Proposal for the 02 series of amendments to Regulation No. 127 (Pedestrian safety) – Proposal of amendments to ECE/TRANS/WP.29/GRSP/2015/8 submitted by the expert from the European Commission as Chair of the Task Force on Bumper Test Area within the Informal Working Group on global technical regulation No. 9 Phase 2*

The text reproduced below was prepared by the experts in the Task Force on Bumper Test Area (TF-BTA) which is a subgroup of the Informal Working Group on global technical regulation No. 9, Phase 2. TF-BTA proposes an amendment to the provisions of the bumper test. This text is based on informal document GRSP-56-41 distributed and endorsed, in principle, during the fifty-sixth session of the Working Party on Passive Safety (GRSP)(ECE/TRANS/WP.29/GRSP/56, para. 32). The modifications to the current text of the UN Regulation are marked in bold for new or strikethrough for deleted characters. **Further amendments requested by OICA are highlighted in red.**

"Figure 5A

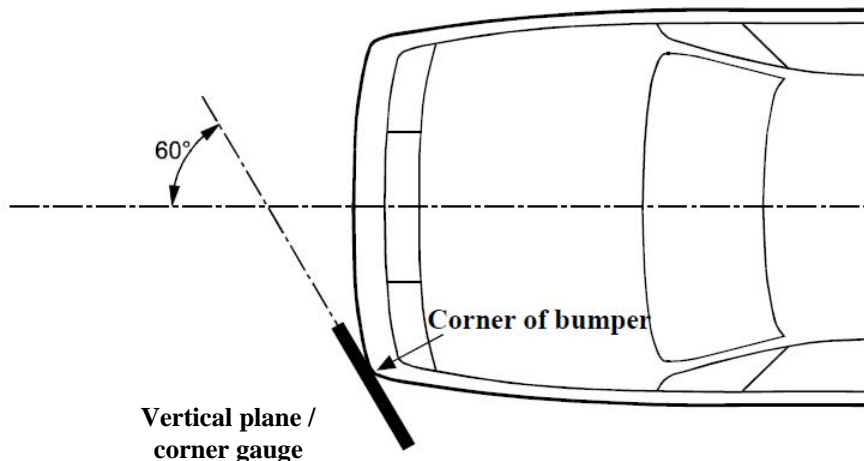
Figure 5, amend to read:

Corner of bumper example (see paragraph 2.17., note that the corner gauge is to be moved in vertical and horizontal directions to enable contact with the outer contour/front fascia of the vehicle)

"2.17. "Corner of bumper" means ~~the transversal position of the vehicle's point of contact with a vertical plane which makes an angle of 60° with the vertical~~ the transversal position of the vehicle's point of contact with a vertical plane which makes an angle of 60° with the vertical

longitudinal plane of the vehicle and is tangential to the outer surface of the bumper (see Figure 5). corner gauge as defined in Figure 5B.

Figure 5B
Corner gauge

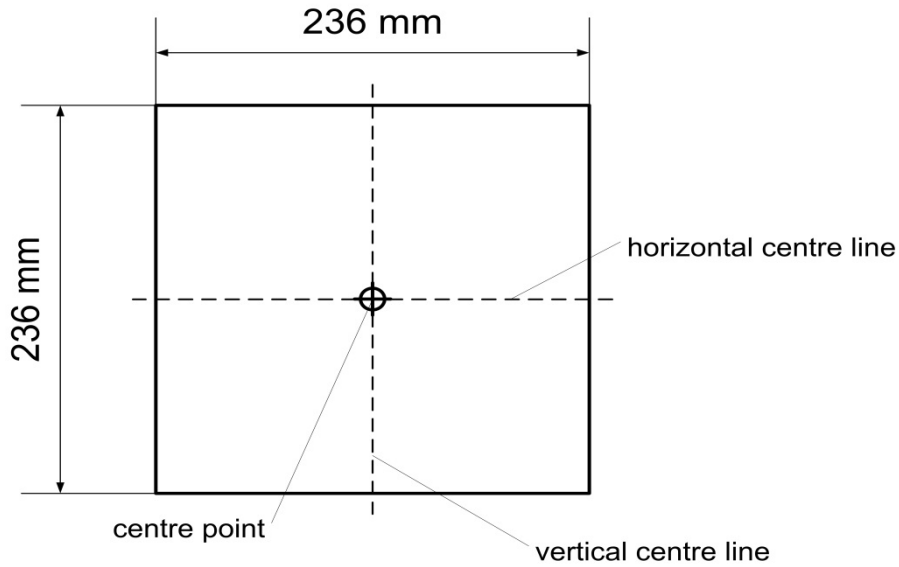
The front surface of the corner gauge is flat.

The centre point is the intersection of the vertical and horizontal centre lines on the front surface.

Figure 5C

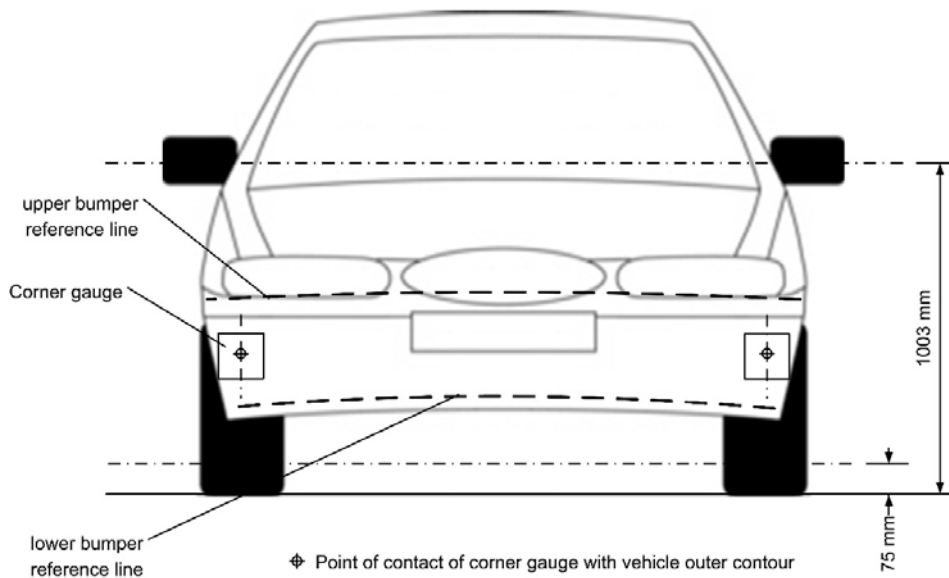
For determination of the corner of bumper, the front surface of the corner gauge is moved parallel to a vertical plane with an angle of 60° to the vertical longitudinal centre plane of the vehicle (see Figures 5A and 5C) at any height of the centre point of the corner gauge between:

Determination of the corner of bumper with the corner gauge (shown in random location)

For determination of the corner of bumper, the gauge is moved to contact the outer contour/front fascia of the vehicle touching at the vertical centre line of the gauge. The horizontal centre line of the gauge is kept parallel to the ground plane.

The corners of bumper on both sides are subsequently defined as the outermost points of contact of the gauge with the outer contour/front fascia of the vehicle as determined in accordance with this procedure. Any points of contact on the top and the bottom edges of the gauge are not taken into account. The rear and side view mirrors and the tyres shall not be considered."

Figure 5D

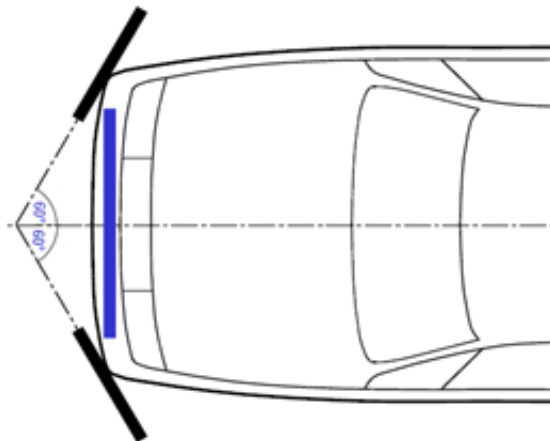
Determination of bumper test area (note that the corner gauges are to be moved in vertical and horizontal directions to enable contact with the outer contour/front fascia of the vehicle)

"2.14. "Bumper test area" means ~~the frontal surface of the bumper limited by two longitudinal vertical planes intersecting points 66 mm inside the defined corners of the bumpers.~~ either the front vehicle fascia between the left and right corner of bumper as defined in paragraph 2.17., ~~minus the areas covered by the distance of 42 mm inboard of each corner of bumper, with this distance to be set from the most outboard point with a flexible tape held tautly along the outer surface of the vehicle,~~ or the outermost ends of the bumper beam as defined in paragraph 2.12. (see Figure 5D), whichever area is wider, **minus the areas inboards covered by a distance of 42 mm in transversal direction. ~~This distance is to be set with a flexible tape held tautly along the outer surface of the vehicle."~~**
